State of New Mexico  
Energy, Minerals and Natural Resources

SUNDRY NOTICES AND REPORTS ON WELLS (DO NOT USE THIS FORM FOR PROPOSALS TO DRILL OR TO DEEPEN OR PLUG-BACK TO A DIFFERENT RESERVOIR. USE "APPLICATION FOR PERMIT" (FORM C-101) FOR SUCH PROPOSALS.)		7. Lease Name or Unit Agreement Name New Mexico Com B

2. Name of Operator Four Star Oil & Gas Company	10. Pool name or Wildcat Basin Fruitland Coal/Blanco P.C.	
3. Address of Operator 11111 S. Wilcrest Houston, Texas 77099

**Four Star Oil & Gas Company**  
**New Mexico Com B1**  
**San Juan County, New Mexico**  
**Proposed Well Schematic**

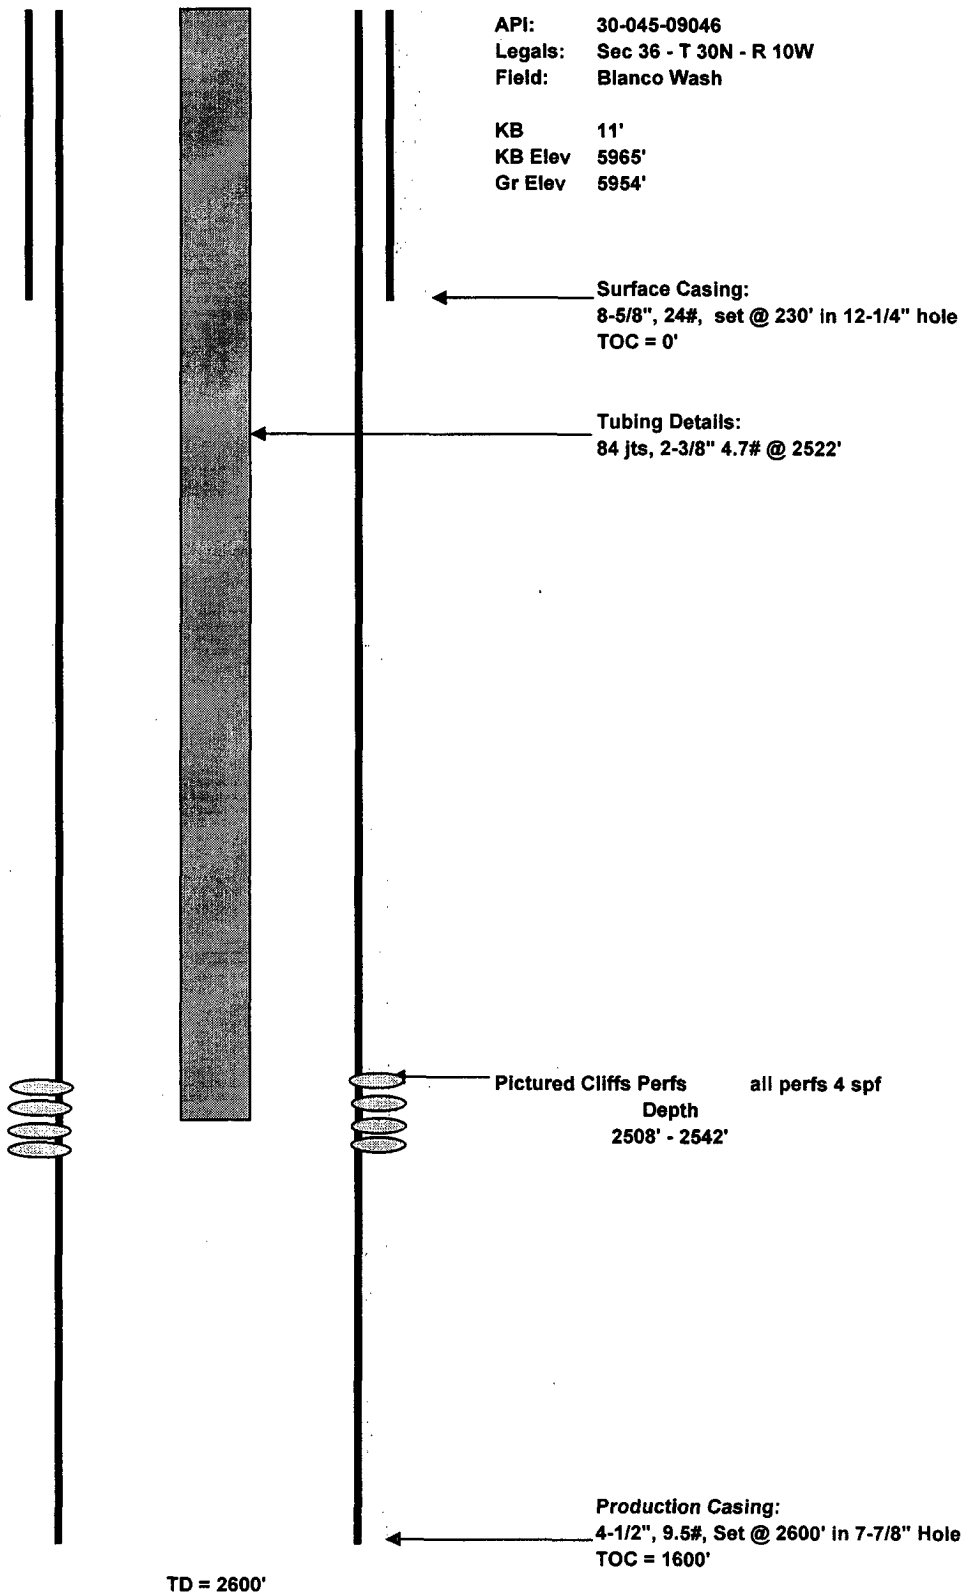
Four Star Oil and Gas requests permission to deepen the subject well while performing a workover to recomplete to the fruitland coal And downhole with the Blanco Pictured Cliffs. This procedure was previously approved in a Sundry Notice filed 3/30/04 and approved 04/05/04. Four Star requests to deepen the well from the plug back TD at 2557' to 2600' which will be even with the casing shoe.

The extra depth will allow the pump to be set lower, and more even with the lower perms, keeping them clear. Moreover, the additional depth will allow debris from the formations to settle below the pump, keeping it clear and reduce the need to pull the pump for servicing.

The additional depth will not be produced.
